Seismic Walkdown Checklist (SWC)

Peach Bottom Atomic Power Station Unit 2
MPR-3815, Revision 3
Correspondence No. RS-12-173

Equipment ID: 2AD003

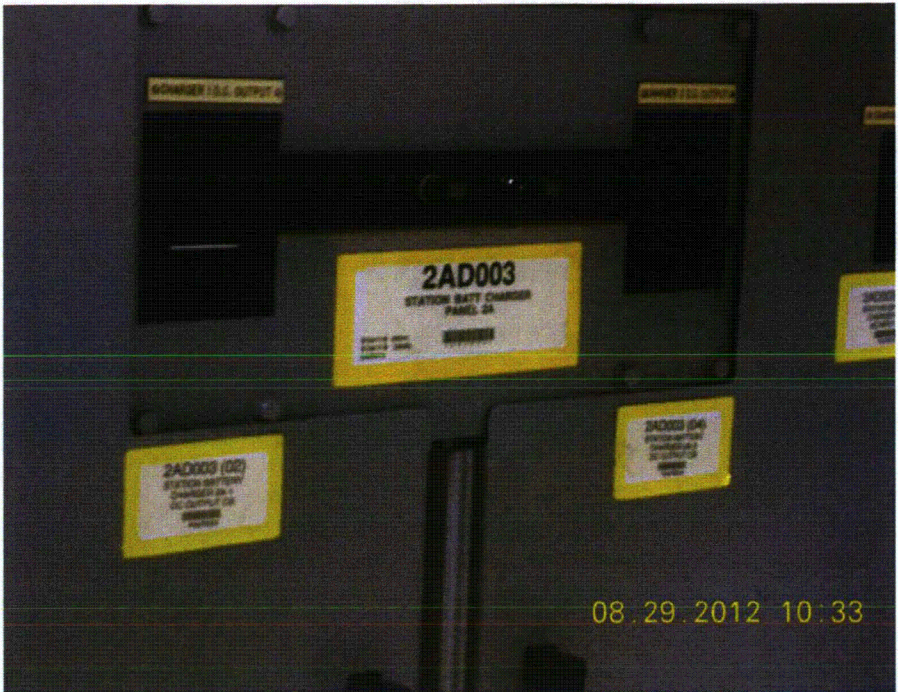
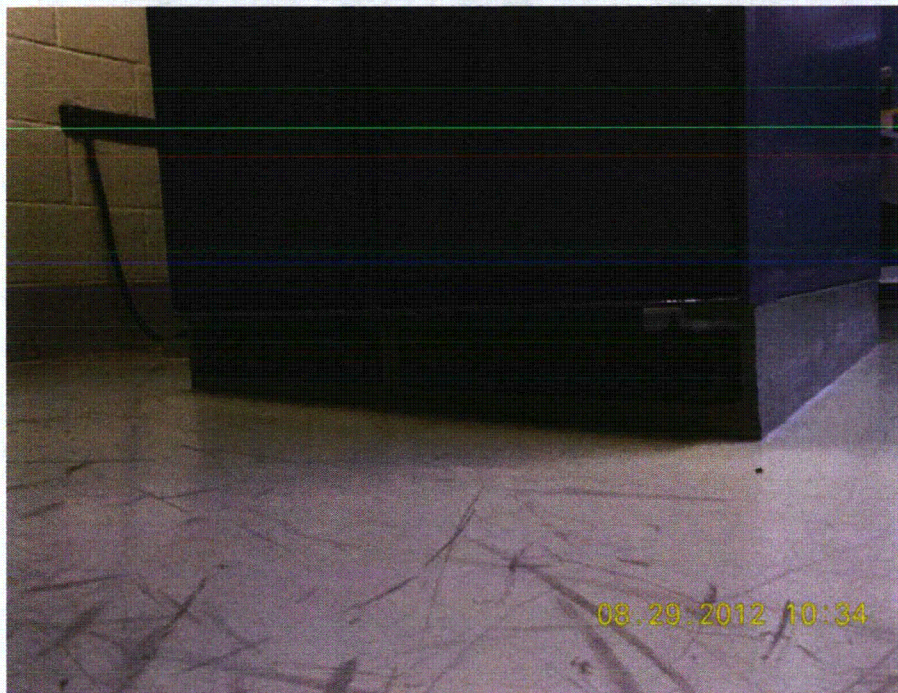
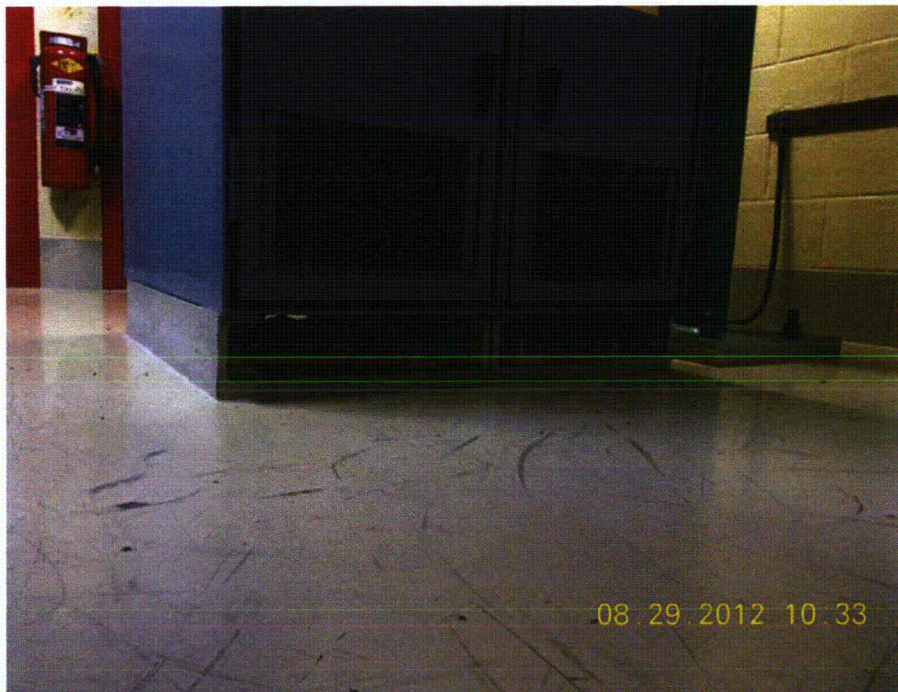
Threaded fire piping is a double-interlock pre-action system (dry piping) per OBD No. P-S-51, Rev. 10
